Crane Division, Naval Surface Warfare Center (NAVSURFWARCENDIV Crane) submits for review and approval, per your comments, a copy of Appendix E4 - Revised Soil Excavation Plan for Rockeye (RKI) of the Final Full Scale Operational Plan for the Bioremediation Project as enclosure (1). Enclosure (2) is the required certification statement.

RESPONSES TO USEPA COMMENTS
ON THE
DRAFT APPENDIX E-4: SOIL EXCAVATION PLAN FOR SWMU 10/15
ROCKEYE
FULL-SCALE OPERATIONAL PLAN FOR SOILS BIOREMEDIATION FACILITY

**APPENDIX E4
SWMU-10/15, ROCKEYE SOIL EXCAVATION PLAN
FOR FULL-SCALE OPERATIONS**

FIGURE E4-4
ROCKEYE GRID LAYOUT
 NSWC
 CRANE, INDIANNA

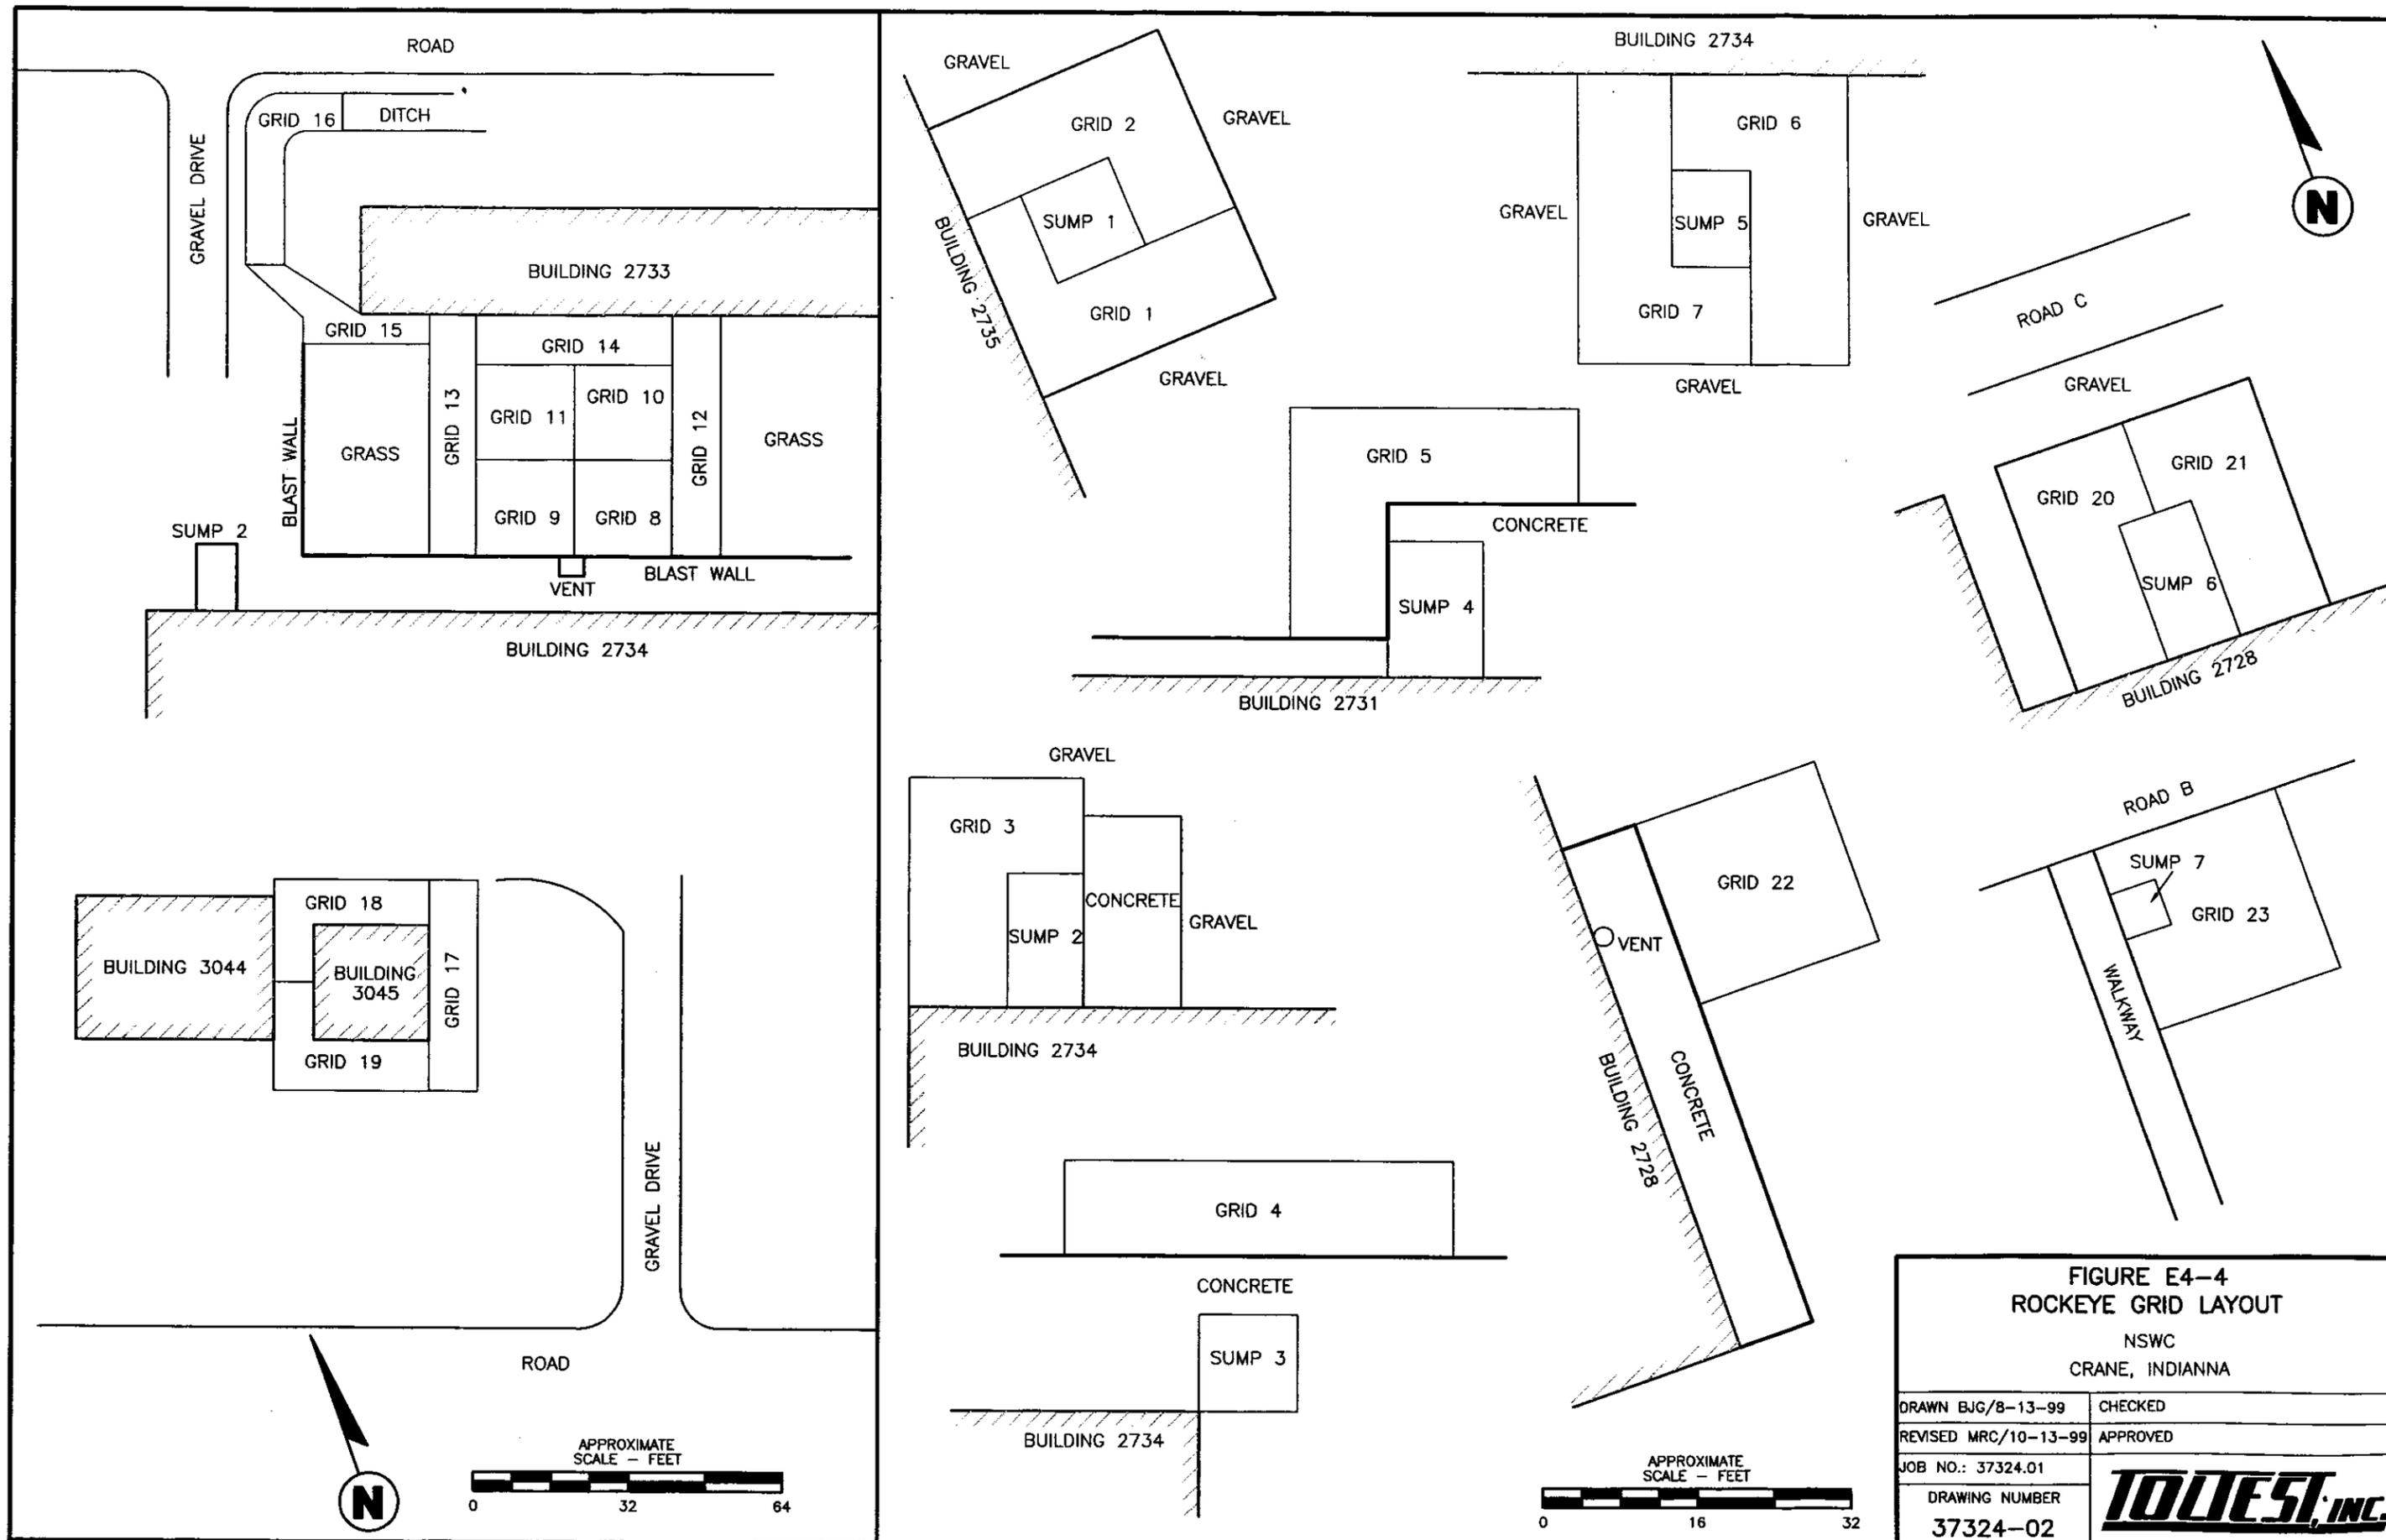
COMMENT 5: In the title for Section 5.4, the word "sampling" is missing. Also, I assume that the figures will show the grid layouts?

COMMENT 7: Section 1.2, Section 4.2, & Attachment E4-4 refer to a General Plot Plan for Rockeye (Drawing No. 538126). I do not have this drawing. I received Figure E4-3 (Drawing No 37324-01) and Figure E4-4 (Drawing No. 37324-02) from Crane with cover letter dated October 21, 1999. Please supply the General Plot Plan drawing. Also make the name references to this drawing consistent between sections.

RESPONSE 5: The word "sampling" has been added to the title of Section 5.4. Figures E4-3 and E4-4 show initial grid layouts.
